DESIGN REVIEW COMMITTEE MEETING

DESIGN REVIEW COMMITTEE STAFF REPORT

2128 Oxford Street FINAL DESIGN REVIEW

To: City of Berkeley
From: Rhoades Planning Group
Date: December 2, 2024
Re: DRCP2022-0014: 2128 OXFORD STREET - Responses to Preliminary Design Review Comments

2 ENLARGED SECTION
A6-3 / SCALE: 3/8" = 1'-0"

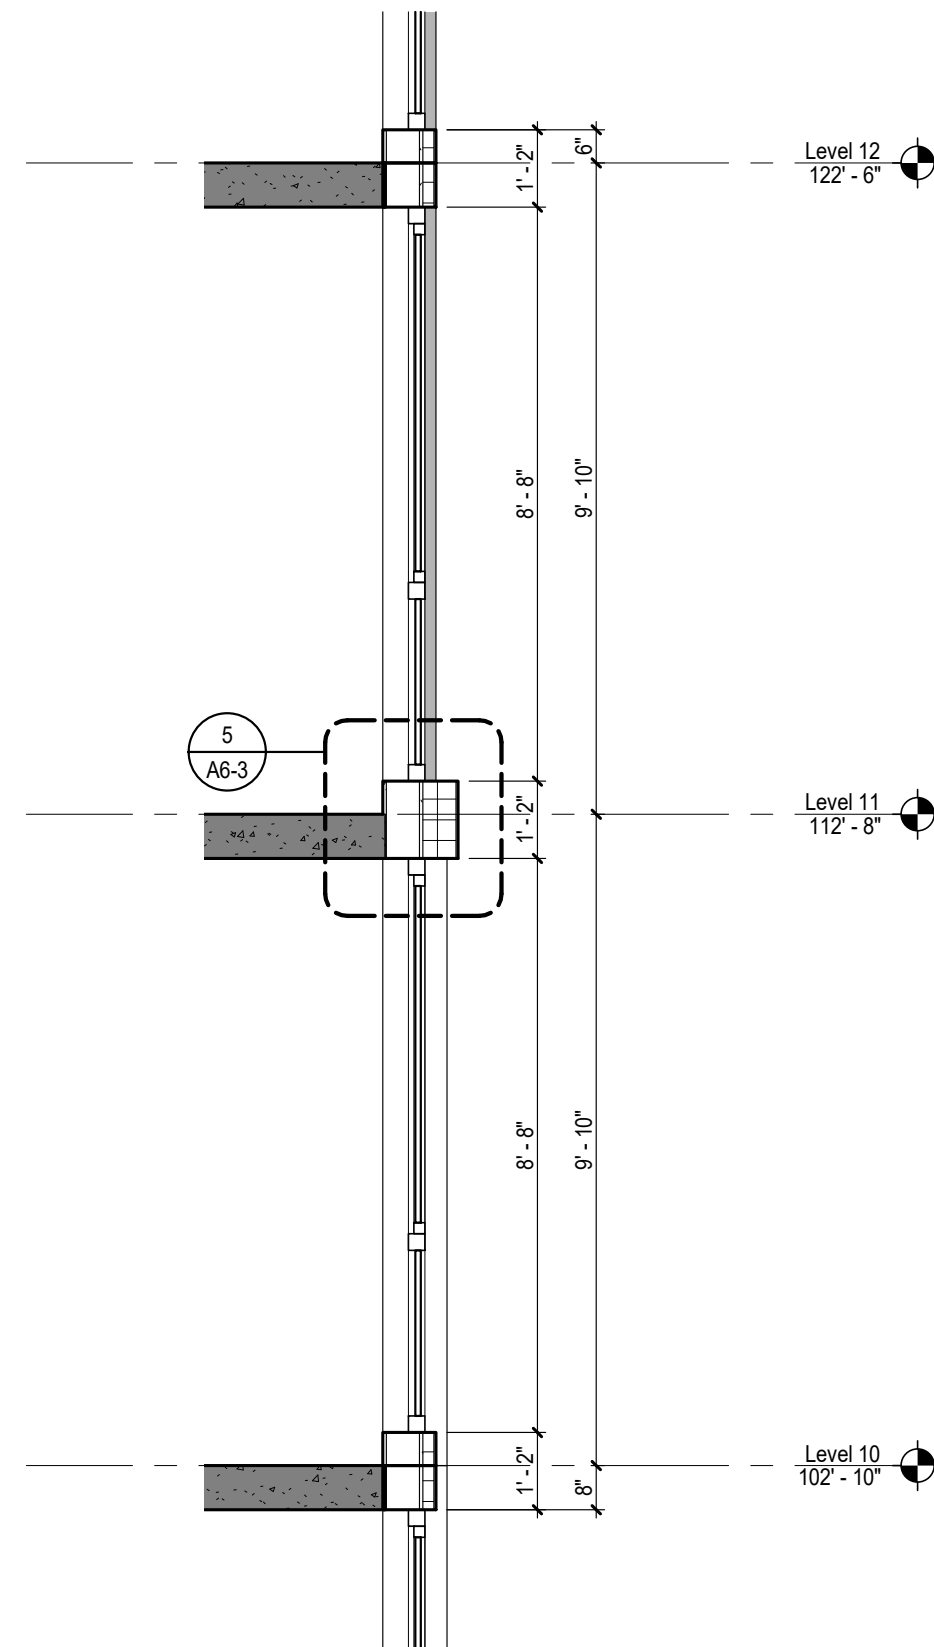
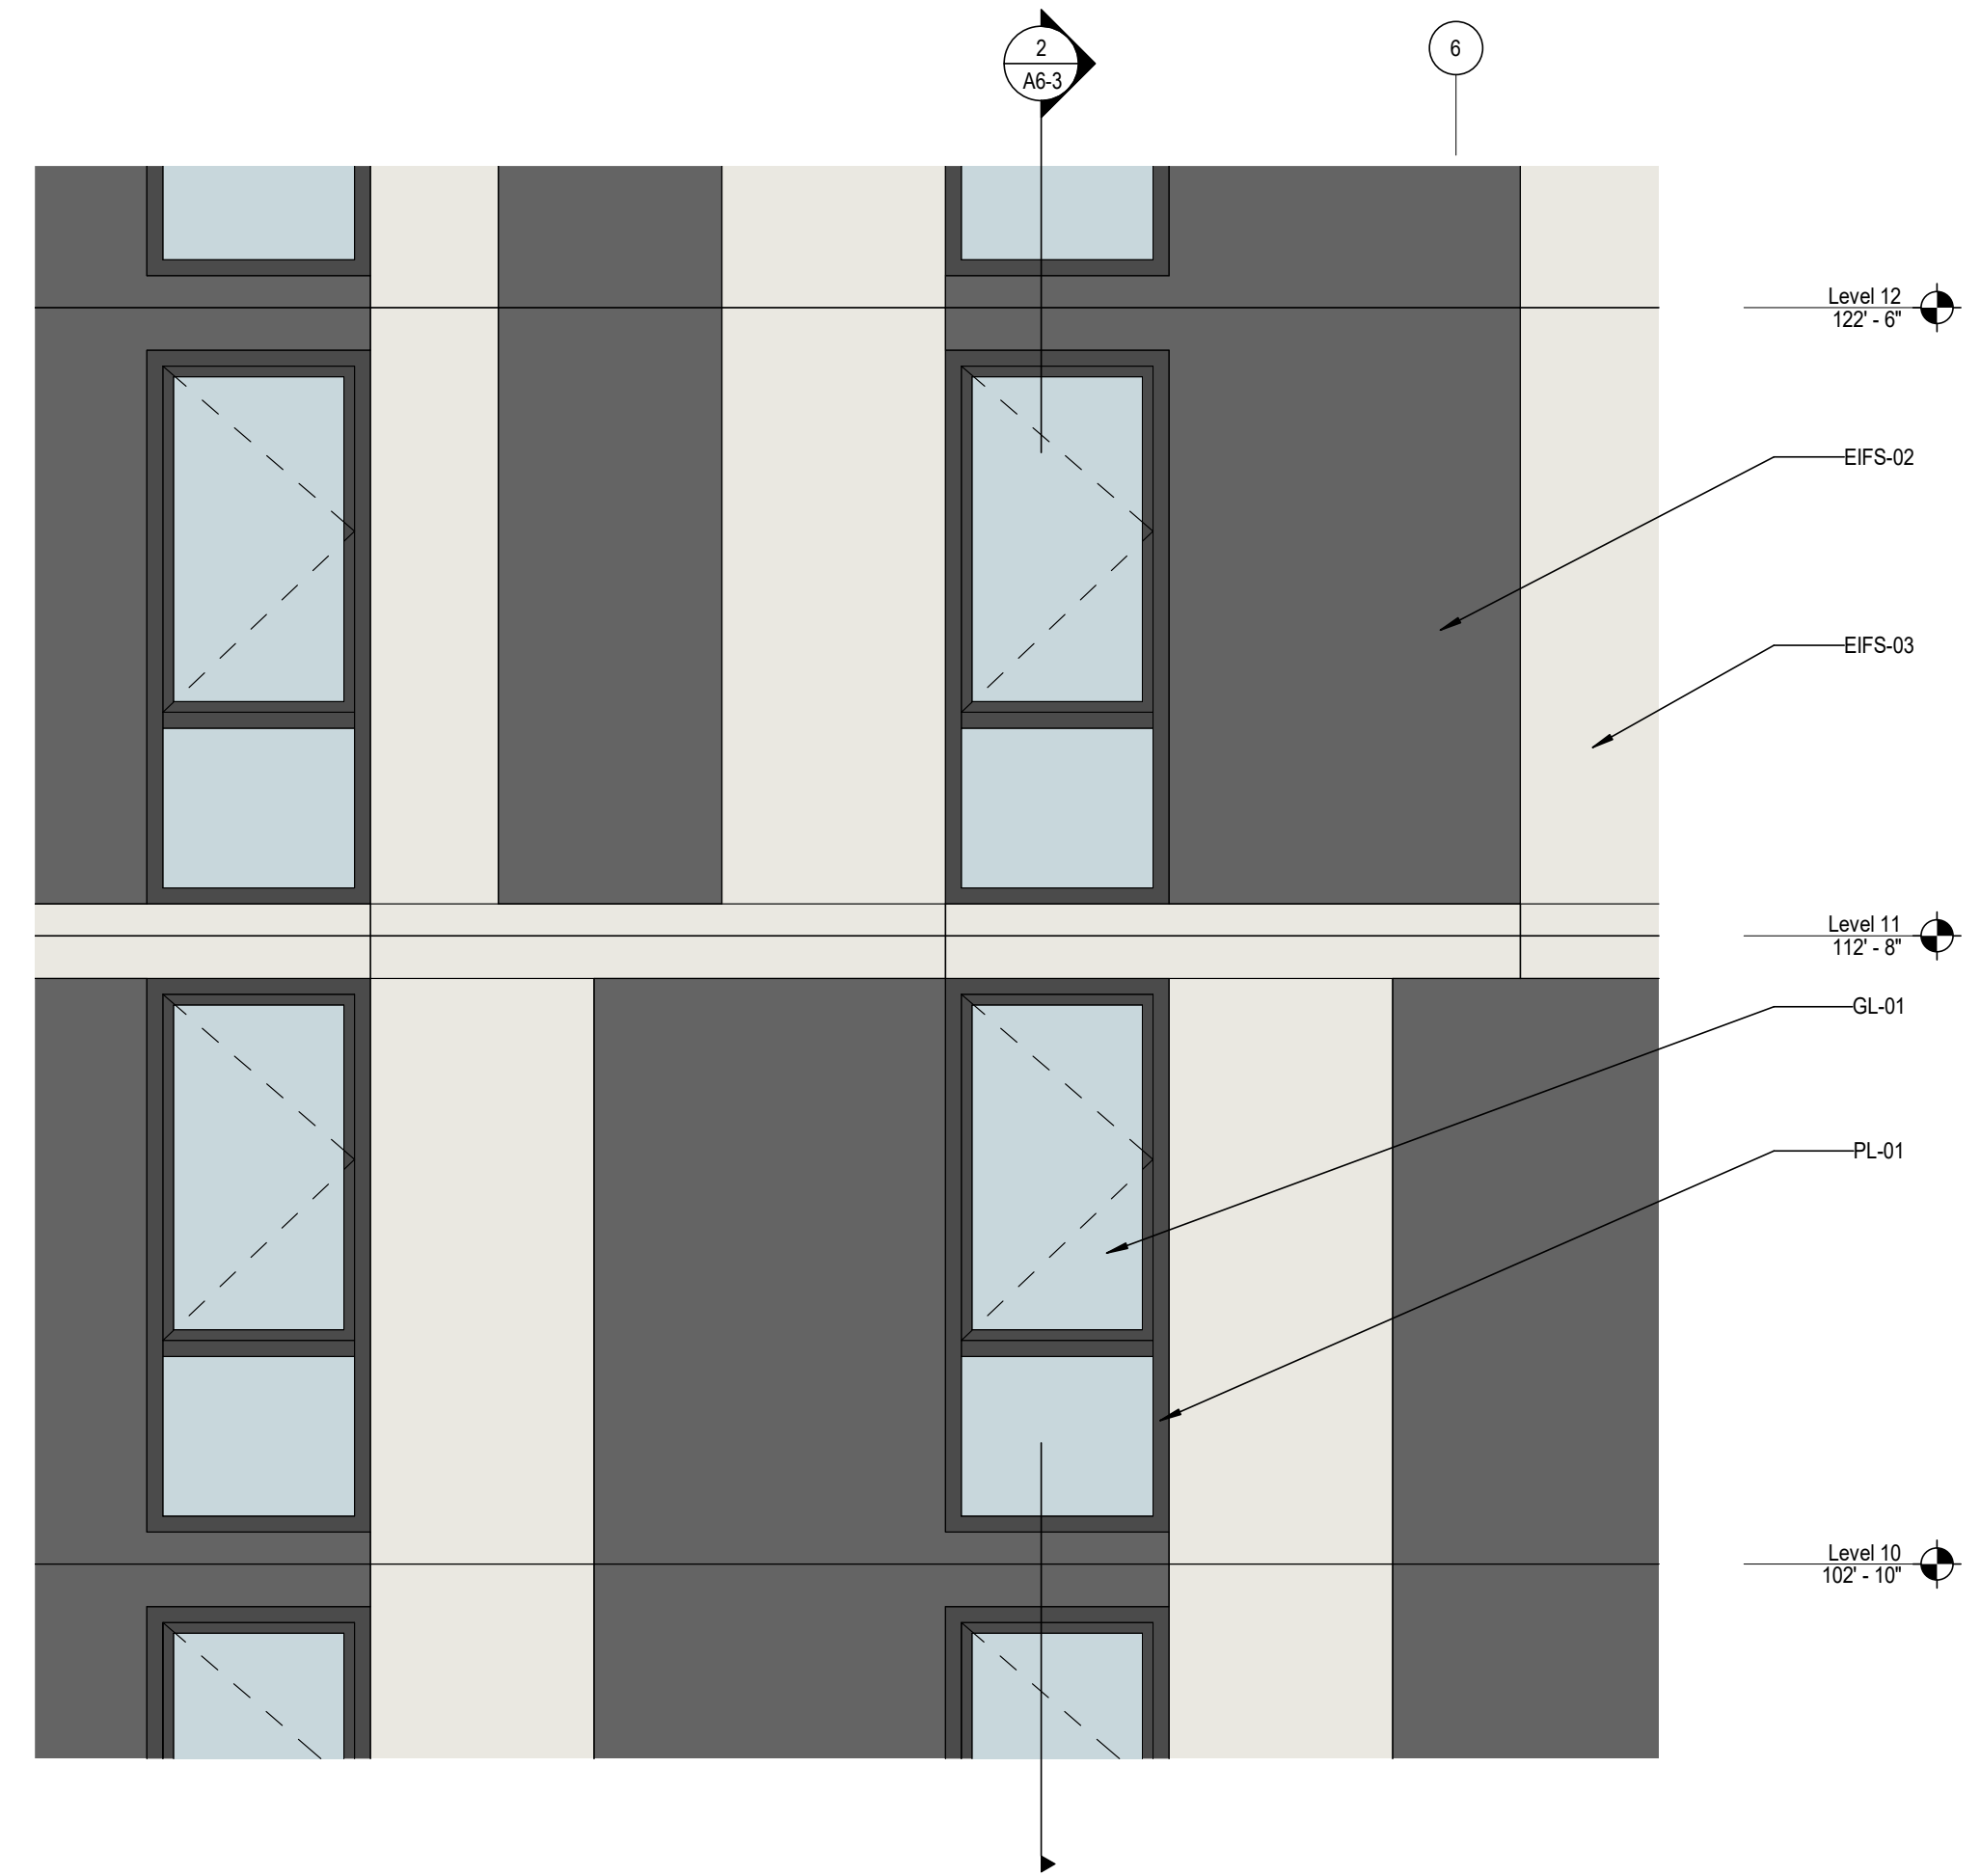
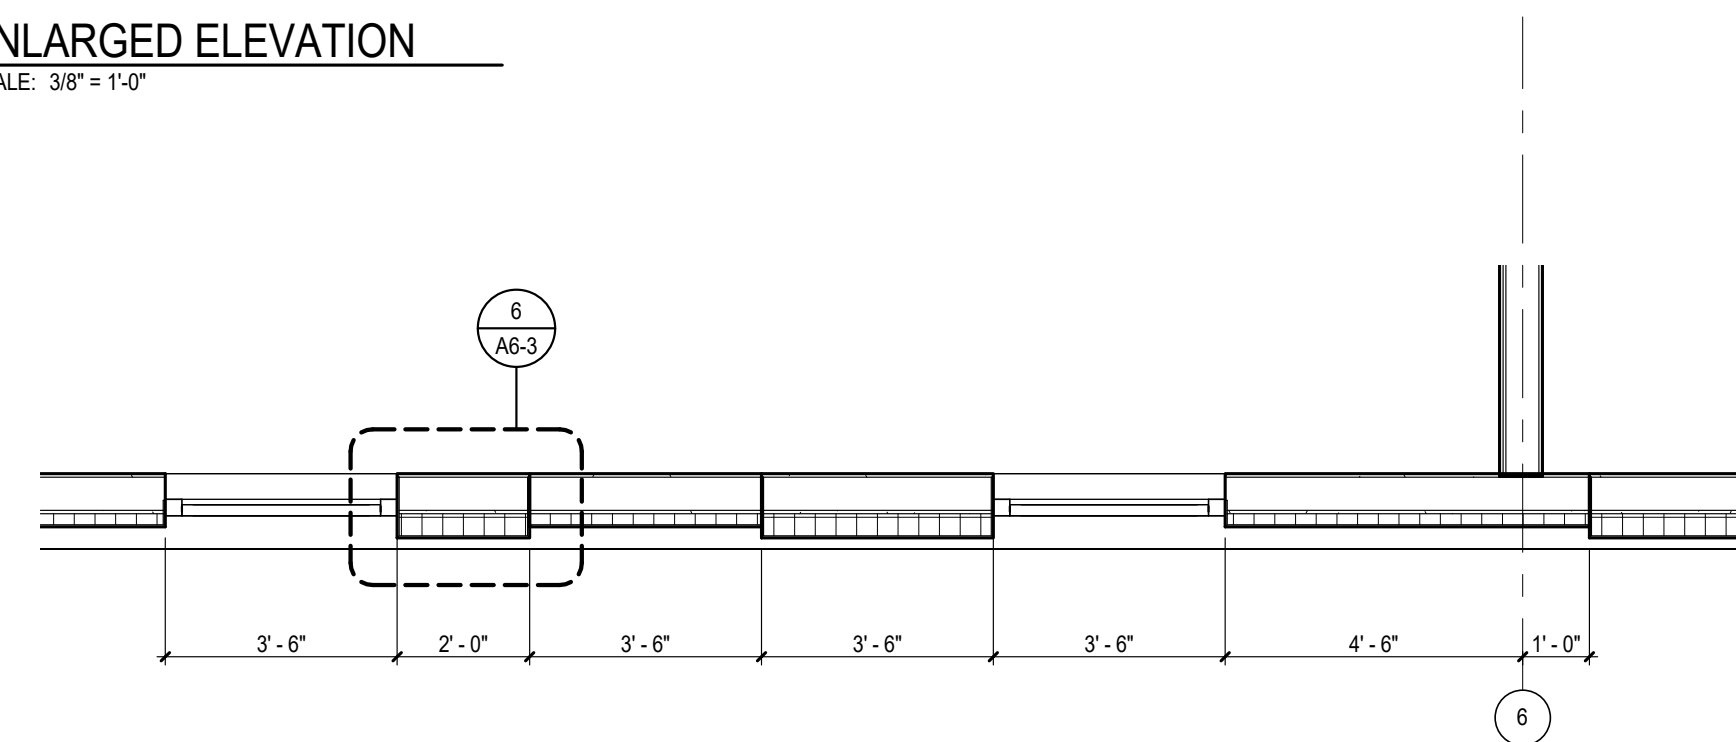
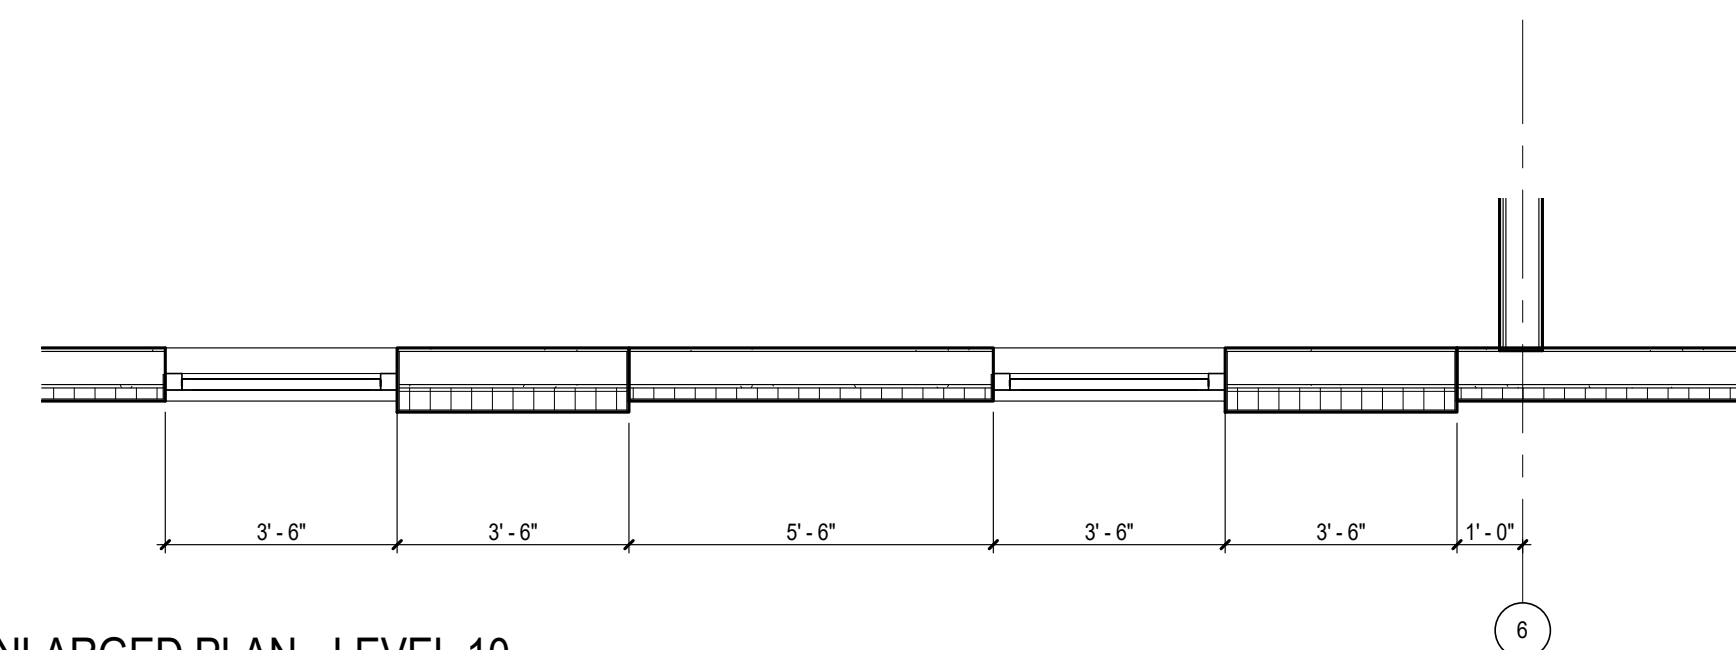
3. Consider more shadow lines and detail on the lighter masses proposed; shadow lines should be deeper, as the building is so large. Shallow ones will not have enough impact.	The façade has depths of 2" and 4" to work within the insulation thicknesses, while creating opportunities for shadow lines. See sheet A6-3.
